City of Surrey
PLANNING & DEVELOPMENT REPORT

File: 7910-0274-00

Planning Report Date: February 7, 2011

in order to permit the development of a 131-bed residential care facility in East Clayton.

1 LIGHTING PLAN
SCALE: 1:250

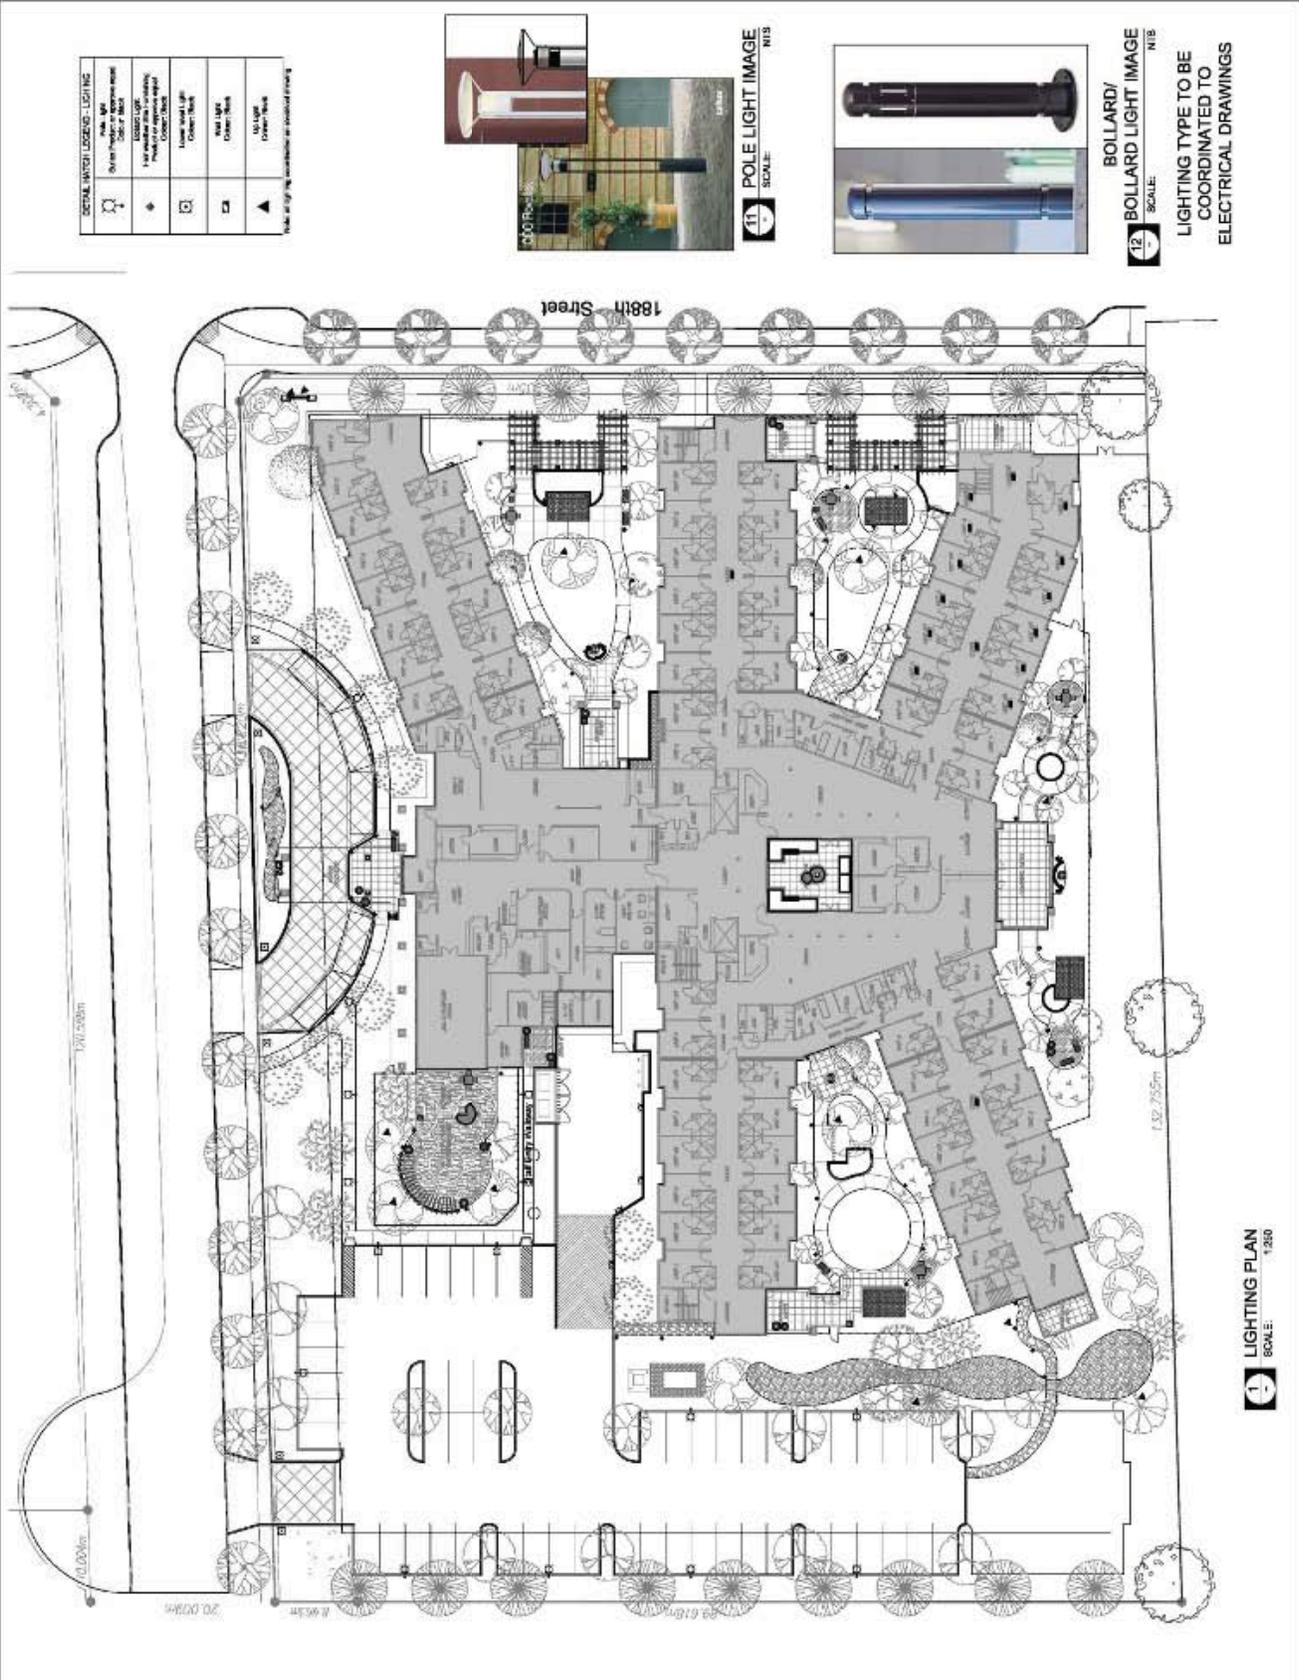
- Clarify how courtyards are accessed.
Maintenance access with gates have been proposed for each courtyard.
- Clarify how courtyards are lighted.
The lighting plan has been provided with the landscaping plans. The landscape lighting will be coordinated with the electrical drawing.

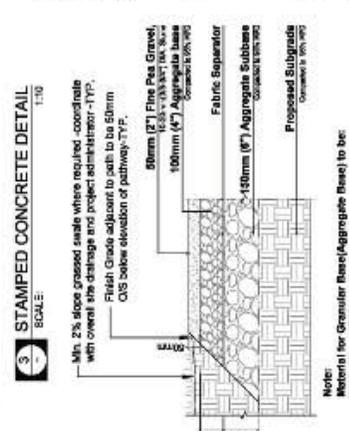
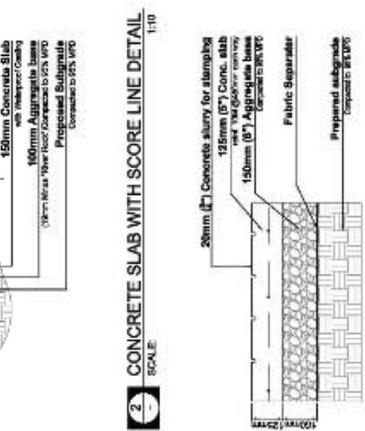
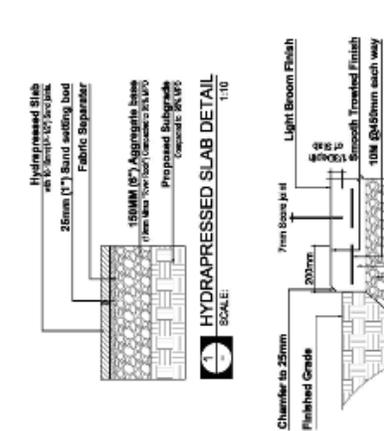
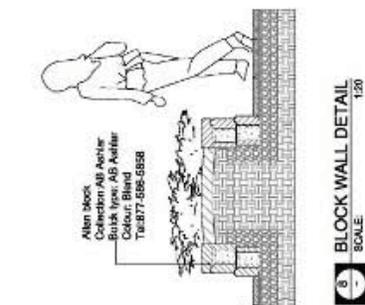
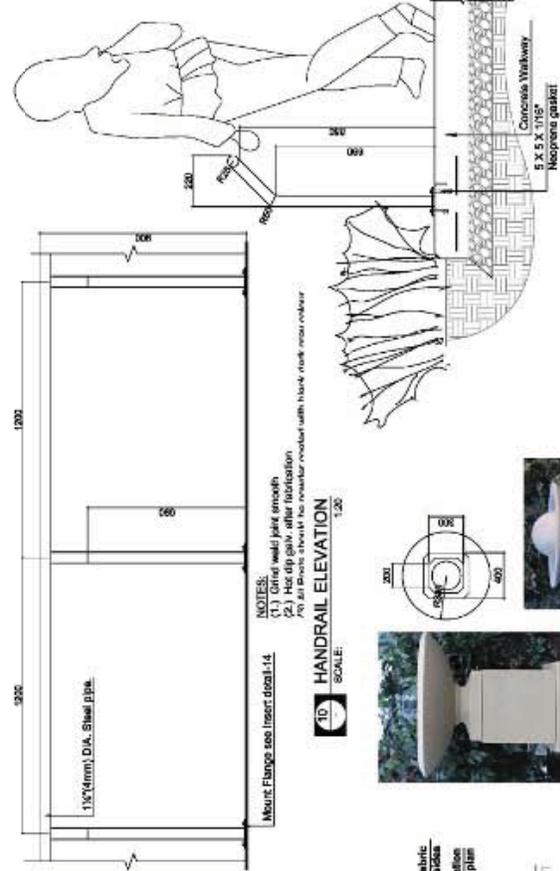
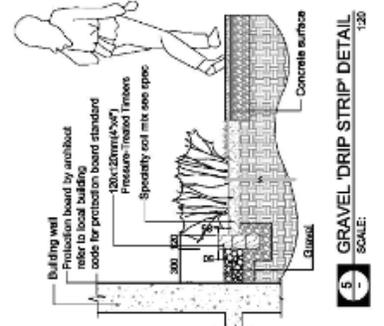
- Not convinced with the fence design; requires design development. Use metal pickets and/or stone columns to carry forward fencing character as seen along frontages.
Fence detail has been provided on Landscape Sheet LD-02. The 1.8 metre (6 ft.) high fence is required by Fraser health Authority. The stepped fence treatment will be created with a 1.2 metre (4 ft.) actual fence by having 0.6 metre (2 ft.) stone or concrete base.

- Storm water management plan is well done. Would like to see details on how the sheet-flow integrates into the rain gardens.
Details and cross-section have been provided in landscape plans, see LD-01 and LD-02. The rain garden will be coordinated with the civil drawings. The rain garden at the front entry will be eliminated. A rock garden has been proposed instead in the same landscape area. Concerns over “splash” from rain leaders lead to this design adjustment.
